DUKE POWER COMPANY

OCONEE NUCLEAR STATION

TECHNICAL SPECIFICATIONS

TECHNICAL JUSTIFICATION

FIGURE 1 - CCW INTAKE AND FIRST SIPHON

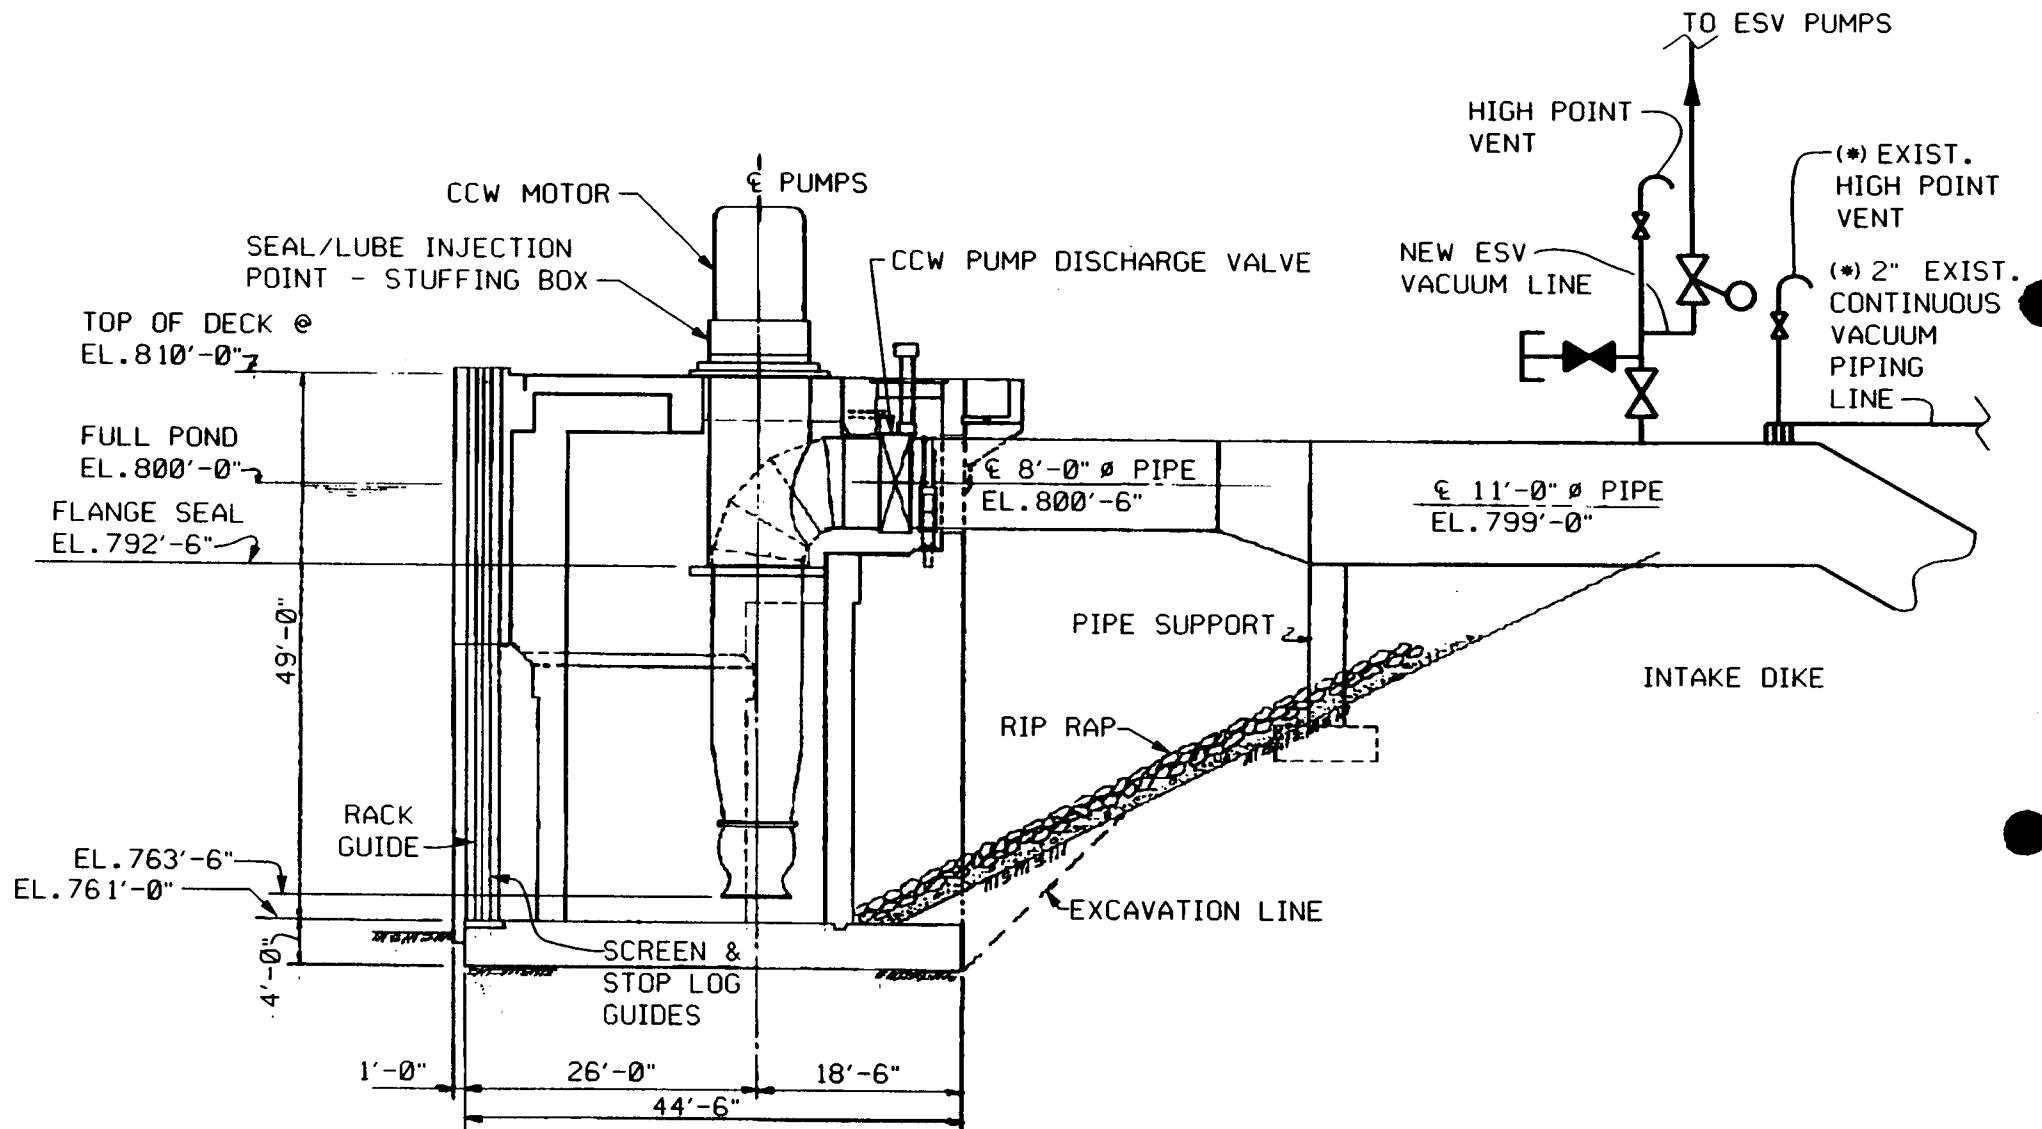
The CCW System takes its suction from the Little River arm of Lake Keowee. As illustrated in Figure 1, the suction of the CCW pumps extends below the maximum draw down lake level of 775 feet. As shown in Figure 2, each ONS unit has four CCW pumps supplying water via two 11 ft pipes into a common condenser intake header. An inter-unit crossover header is also provided upstream of the condensers. The LPSW System for each unit takes suction from the crossover header in order to supply various safety-related loads. These loads include the Low Pressure Injection (LPI) coolers and the Reactor Building Cooling Units. The LPSW System is shared for Units 1 and 2, and independent for Unit 3. During normal operation, the CCW crossover header is aligned to all three ONS units and CCW pumps provide flow to the suctions of the LPSW Systems for all three units. Occasionally, the CCW System for a given Oconee unit may be manually isolated from the CCW crossover header for maintenance or testing.

The ECCW System can be divided into two distinct parts based on the piping configuration. The CCW piping has two high points, one at the discharge of the CCW pumps and one downstream of the condensers on the emergency discharge piping. These high points are referred to as the "first siphon" and the "second siphon", respectively. The first siphon takes lake water from the intake canal, lifts it into the CCW piping through the CCW pumps, and supplies flow to the CCW crossover header in the Turbine Building basement where the LPSW pumps take their suction. The second siphon

FIGURE 2 - CCW PUMP SEAL WATER SYSTEM

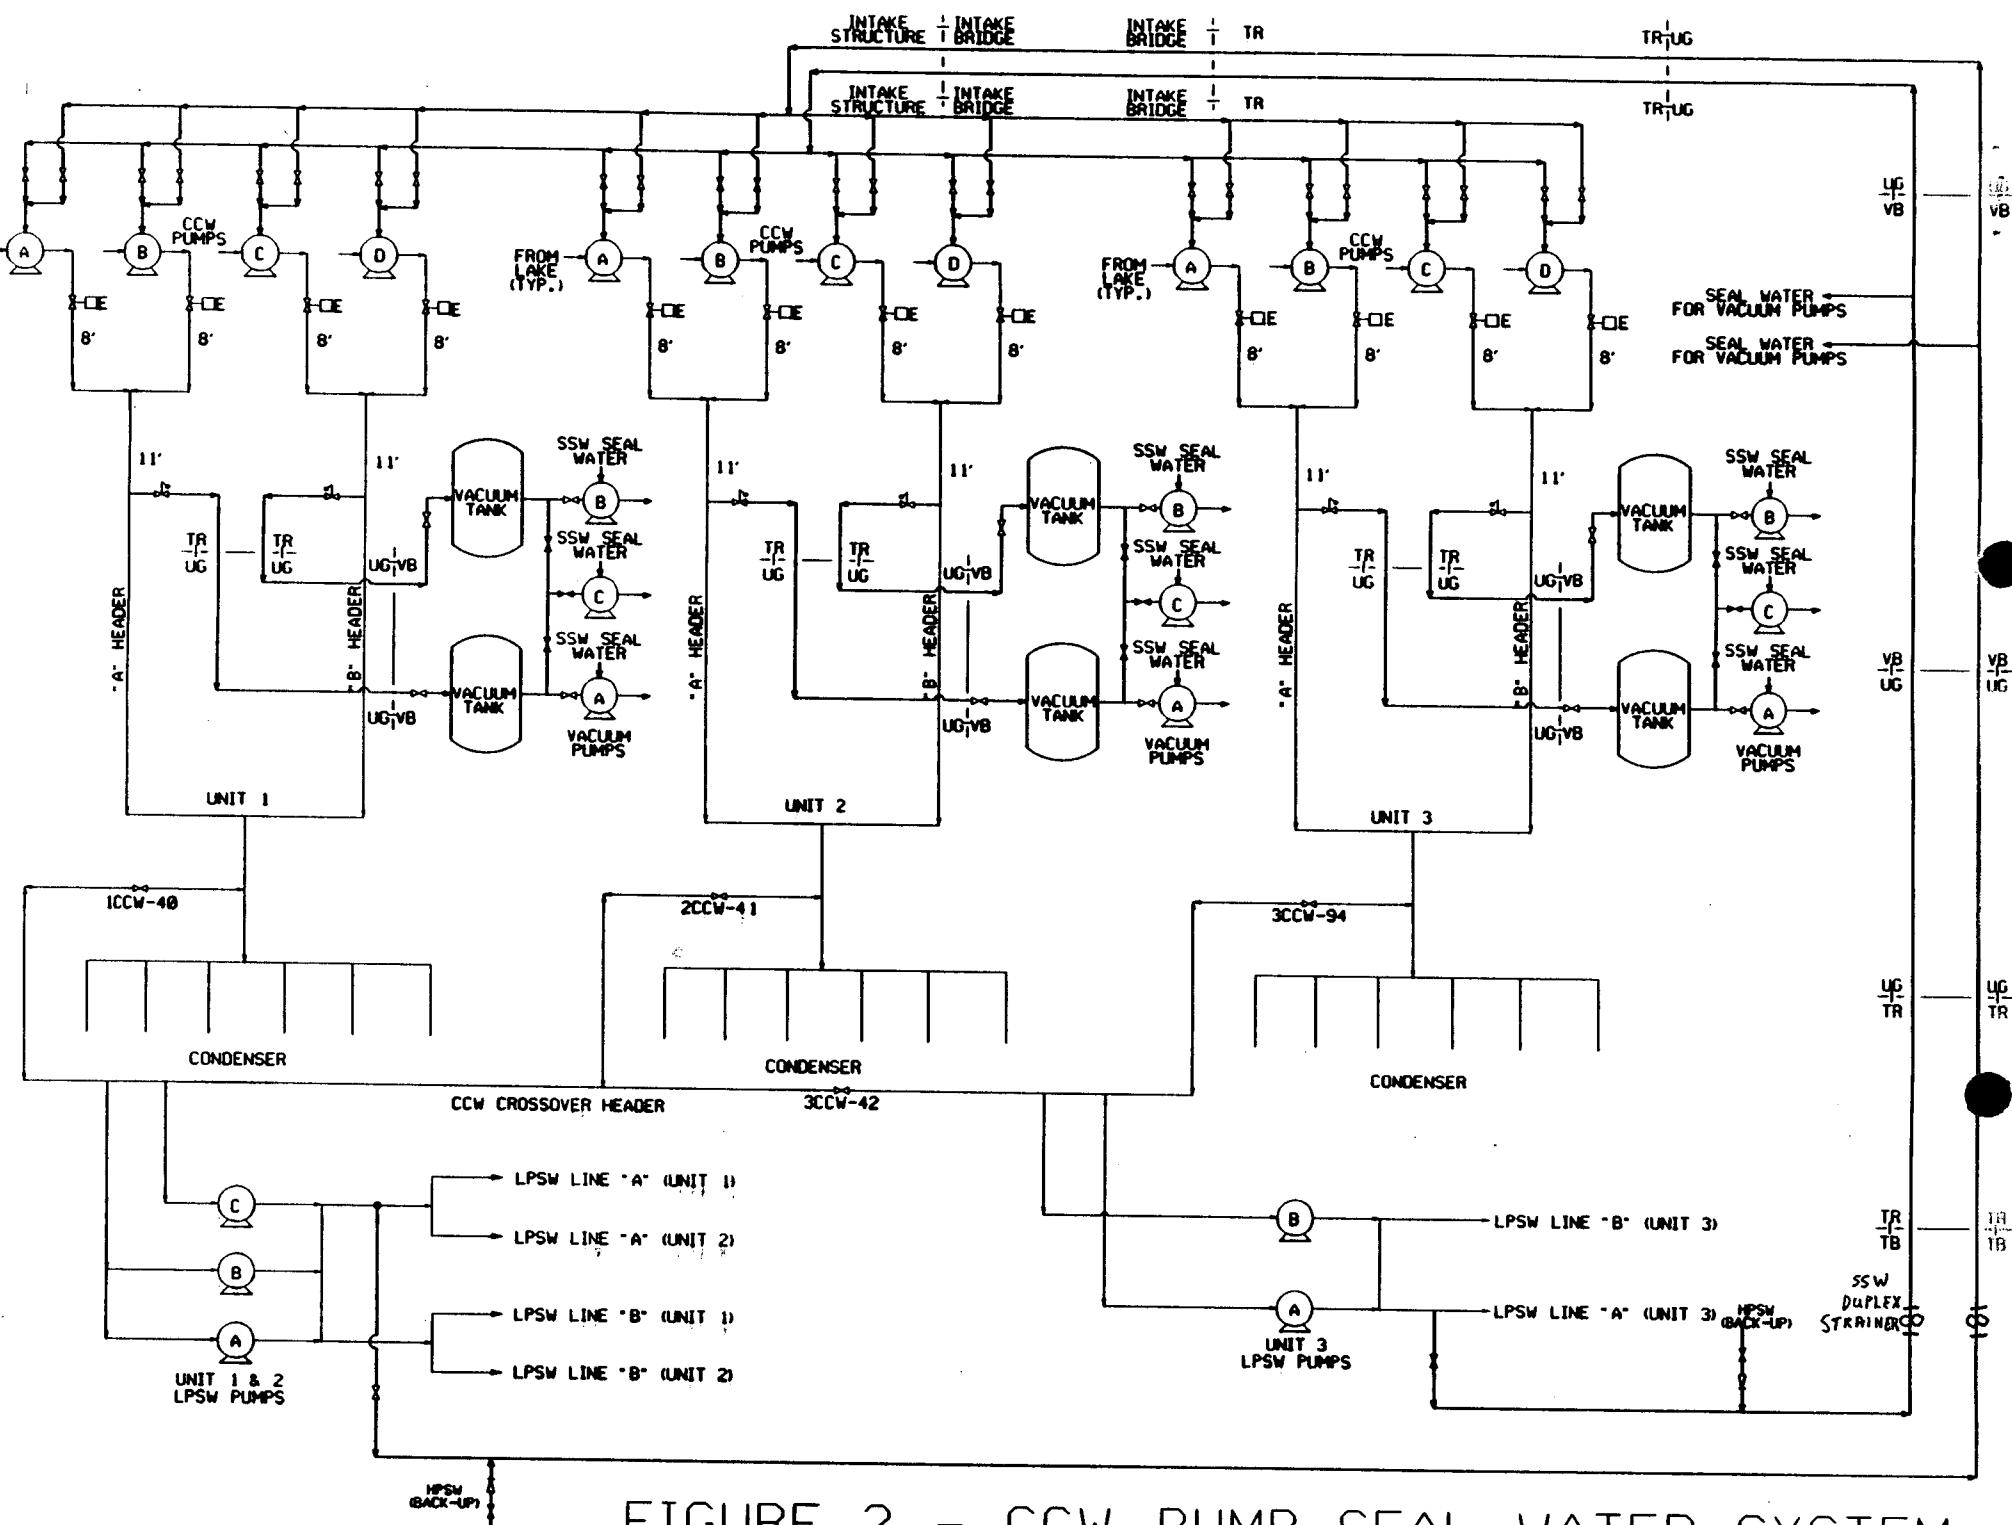
A total of nine vacuum pumps are provided (three per unit). Each vacuum pump is sized to handle the maximum expected air accumulation associated with one ECCW siphon header. The ESV pumps are of a liquid ring design. They have an open design with the sealing water being discharged from the pump. Seal water supply is controlled by a solenoid valve that is interlocked with pump controls. This sealing water will be provided from the new Siphon Seal Water (SSW) System as shown in Figures 2 and 3.

Two SSW headers are routed from the LPSW System in the turbine building to the CCW intake structure, as shown in Figure 2. One header taps off the Units 1&2 LPSW System, and the other taps off the Unit 3 LPSW System. Both taps are downstream of LPSW pump cross-connects. An HPSW supply line is connected to each of the SSW headers in the turbine building to provide a means for flushing the lines.

FIGURE 3 - ESSENTIAL SIPHON VACUUM SYSTEM

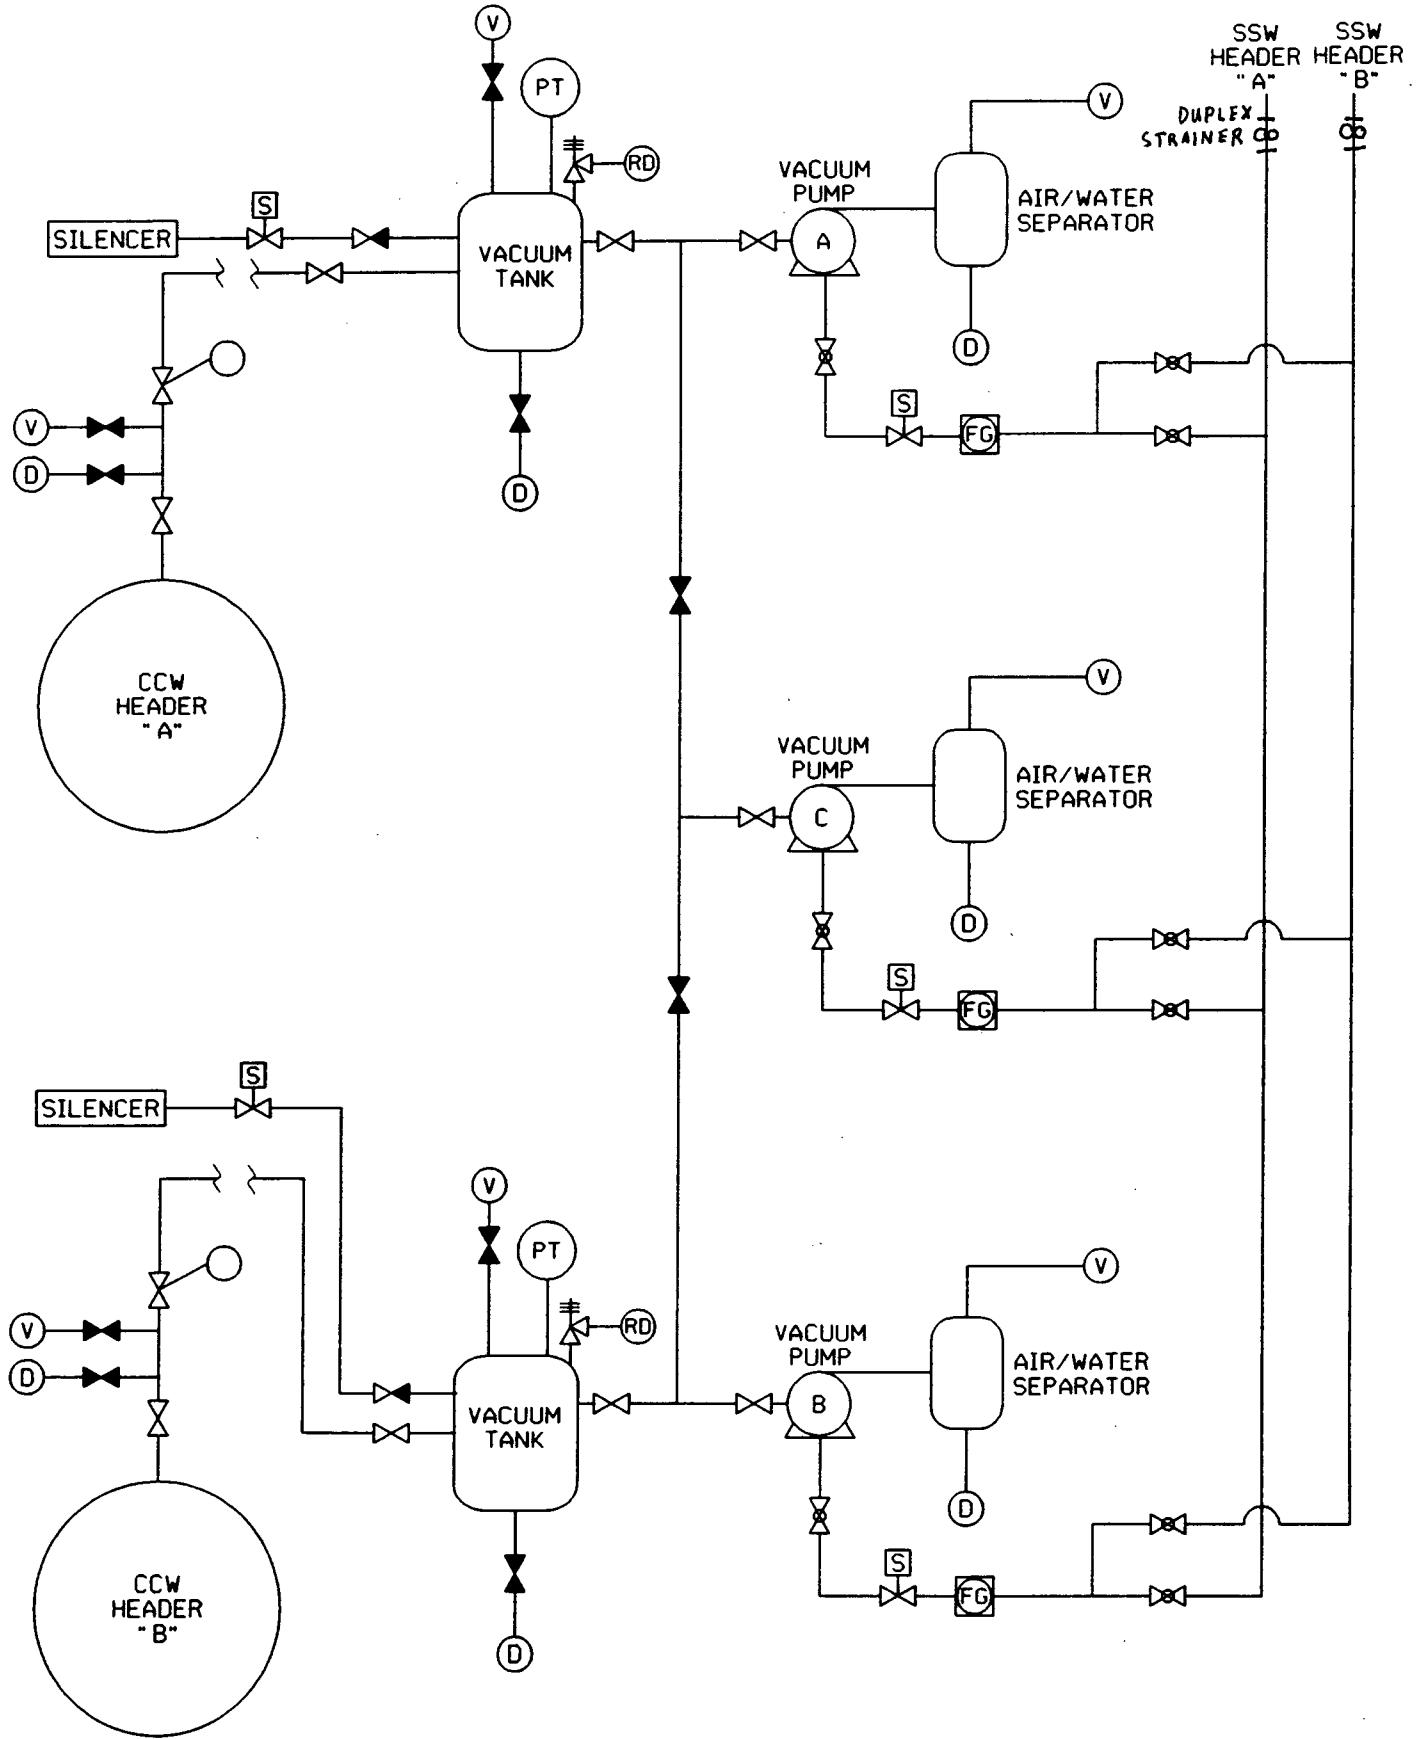
The new ESV System consists of three vacuum pumps per unit. Each unit has an independent ESV System with the exception of the sealing water, which is provided from Siphon Seal Water (SSW) headers. A simplified flow diagram of the ESV System for a single unit is provided in Figure 3. One continuously operating vacuum pump will normally be aligned to each 11 ft. ECCW siphon header. A third pump is provided as an installed spare pump which can be aligned to replace one of the two normally aligned pumps. The vacuum piping is connected to the top of the ECCW siphon header and contains an automatic float valve to prevent water from entering the system during normal operation. Piping from each header goes to a small receiver tank. This allows for the collection and drainage of any entrained liquids and adds system capacitance. The tank also provides a suitable location for installation of instrumentation.

A float valve is provided near the CCW header connection to prevent water from entering the vacuum lines. In addition, an isolation valve and a test vent valve were added upstream of the float valve as shown in Figure 3. The test vent valve will allow air to be introduced into the system to demonstrate the ability of the ESV System to remove it.
